Kincardine Floating Offshore Windfarm

ES Additional Information Addendum
KOWL

23 September 2016

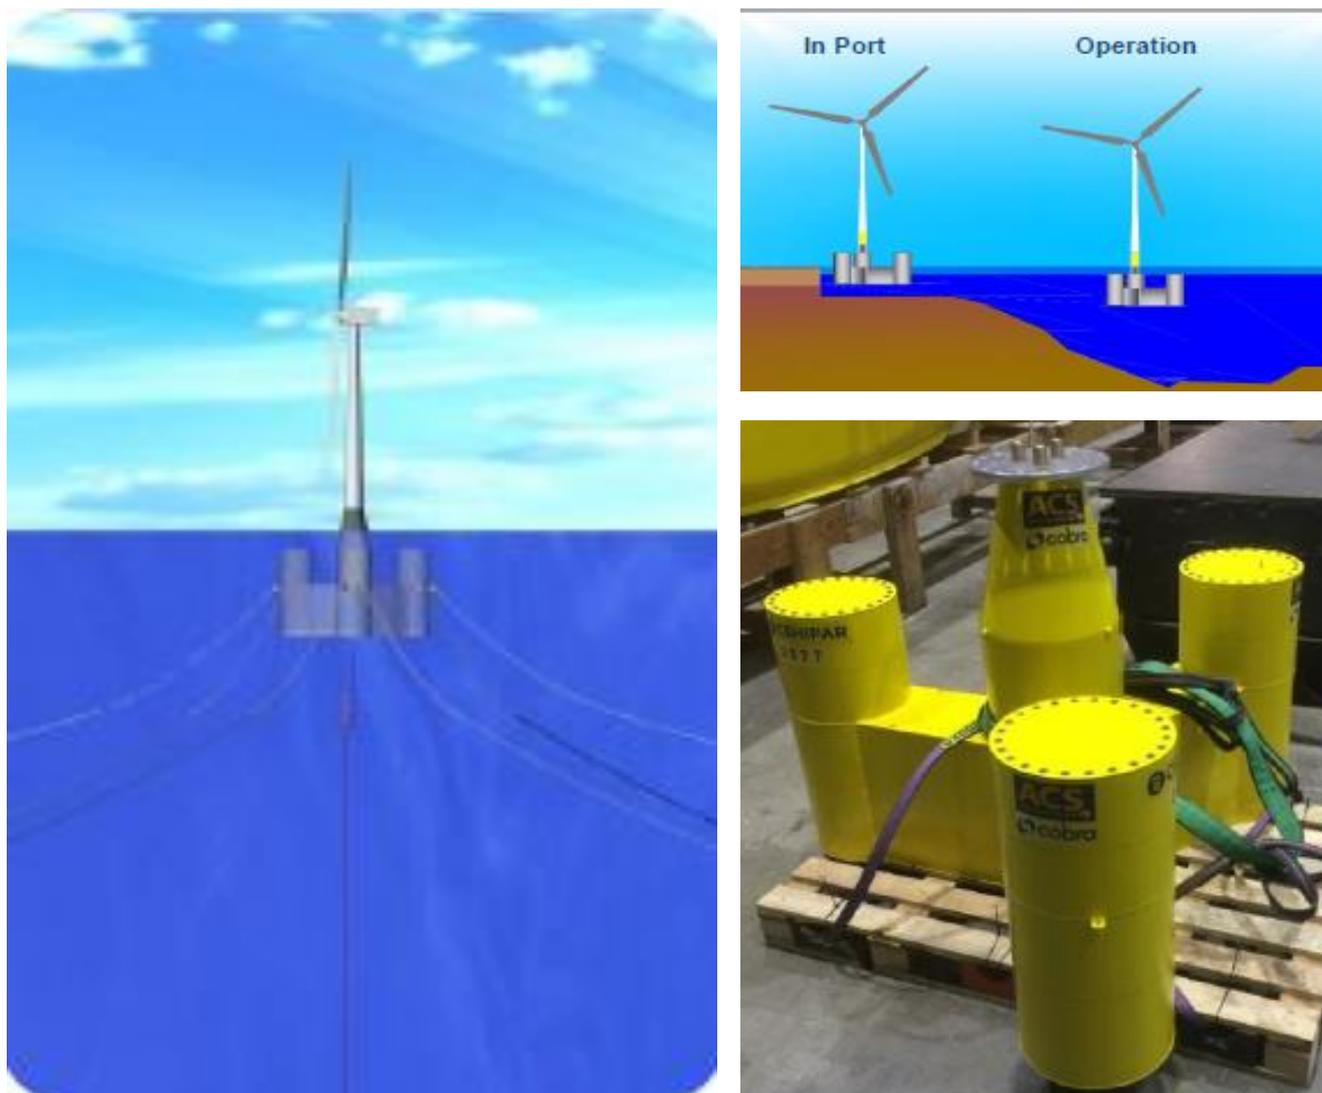
As the Project has progressed and design work has been carried out, KOWL have decided to utilise Cobra's SEMI-SPAR concrete substructure technology in preference to the Windfloat semi-submersible prototype as presented in the Original ES.

The technology consists of a central column connected to three outer columns by rectangular pontoon sections, with the outer columns located below the water surface when operational. The WTG is mounted centrally on the central column above the transition cone. The concept embraces the low-cost and constructability benefits of concrete with favourable spar motions during operations and enhanced semi-submersible (columns partially submerged) stability characteristics for alongside WTG installation and transit.

It should be noted that the change in sub-structure does result in an increase of substructure that is below the waterline (draft of 36m) compared to the semi-submersible (14m) (N.B. this is not a parameter that was included in the Original ES Rochdale Envelope table (Table 1-3) as reference below). The outer buoyancy chambers are now below the water surface, with the top of each one being approximately 6 m below the water surface at all states of the tide and this will mean a reduced above surface cross sectional area for the main structure and they will allow the support vessels to approach the structure to unload service engineers onto the structure safely from all directions.

This increase in draft or the location of the outer buoyancy chambers does not pose any additional impacts to marine navigation and would reduce the collision risk for smaller vessels and recreational boats that have drafts shallower than 6 m to the above water element of the structure (above water width reduced from approximately 65m to 20 m.
